SUBJECT: REQUESTS FOR ADDITIONAL INFORMATION FOR THE REVIEW OF THE WATERFORD STEAM ELECTRIC STATION, UNIT 3, LICENSE RENEWAL APPLICATION – SET 18 (CAC NO. MF7492)

**WATERFORD STEAM ELECTRIC STATION, UNIT 3**  
**LICENSE RENEWAL APPLICATION**  
**REQUESTS FOR ADDITIONAL INFORMATION – SET 18**  
**(CAC NO. MF7492)**

**RAI 4.2.1-2:**

Figure 1: PWR RPV neutron fluence profiles.

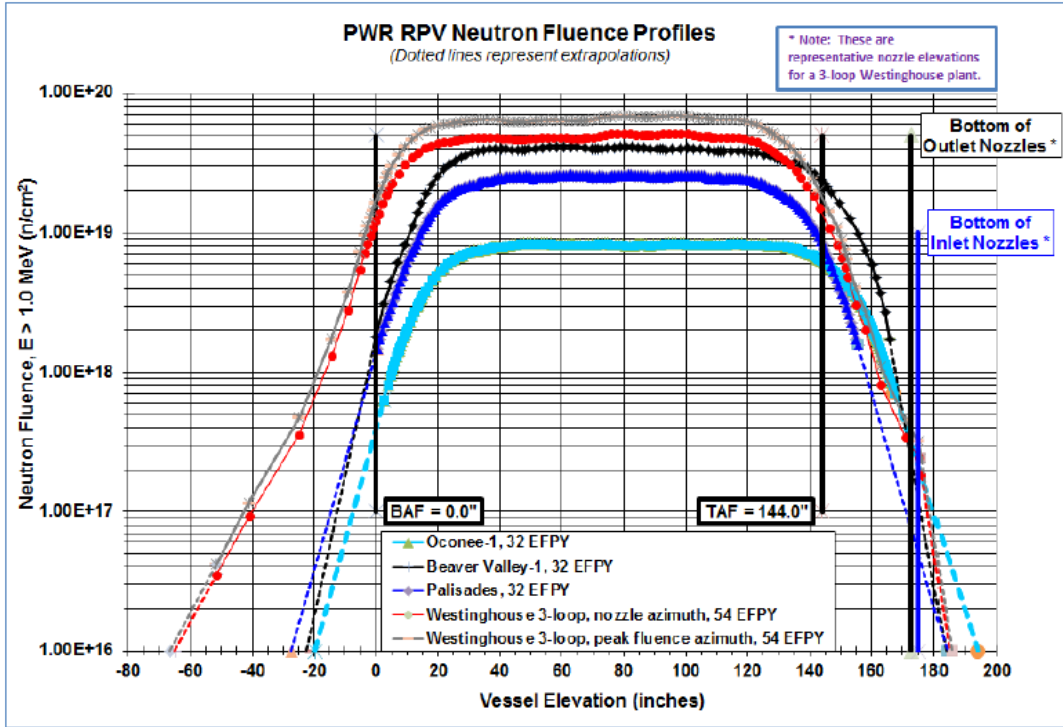
Data from Westinghouse's ex-vessel neutron dosimetry (EVND) program has been shown to span from approximately 5 to 9 feet above the core midplane – a relatively wide range considering the change in flux gradients and magnitude of flux change in this 5 to 9 foot span.<sup>1</sup> Note that 5 and 9 feet above the core midplane corresponds to approximately 132 and 180 inches, respectively in Figure 1<sup>2</sup>, which shows actual PWR RPV neutron fluence profiles; corresponding regions for Waterford 3 are shown in Figure 2.

The applicant does not specifically identify where the “off-midplane capsules” are located in relation to “near the ends of the active fuel” for Waterford 3 (e.g., this could mean just below the

top end of the active fuel). Considering that specific locations of off-midplane capsules have not been provided, especially in relation to the upper-to-intermediate shell circumferential weld, which has the 55-EFPY adjusted reference temperature almost equivalent to that of the limiting beltline material, the NRC staff cannot determine whether the off-midplane capsules are actually providing the intended validation for this “area of steep flux gradients”.

- a) Indicate the distance relative to the core midplane for each of the 44 EVND off-midplane capsules corresponding to Table 19 in Attachment 3 so that the NRC staff can verify that the data labeled as off-midplane is actually applicable to the above top of active fuel region (or area of steep flux gradients) being qualified. Include valid data not in the set of 44 that is at approximately 9 feet above the core midplane (e.g., Capsule ID BC, BE, and BG listed in Table 3-1 of WCAP-18100-NP).

- b) Provide summary tables with individual reaction measurement-to-calculated (M/C) and best-estimate-to-calculated (BE/C) ratios and fluence rate ( $E > 1$  MeV) BE/C ratios (e.g., Table C-1 of WCAP-18100-NP) for the subset of EVND capsules that correspond to the region nearest to the upper-to-intermediate shell circumferential weld so that the NRC staff can verify that the fluence calculational methodology used produces results at the upper-to-intermediate shell circumferential weld that remain within the calculational uncertainty allowance prescribed in RG 1.190, Regulatory Position 1.4.3.
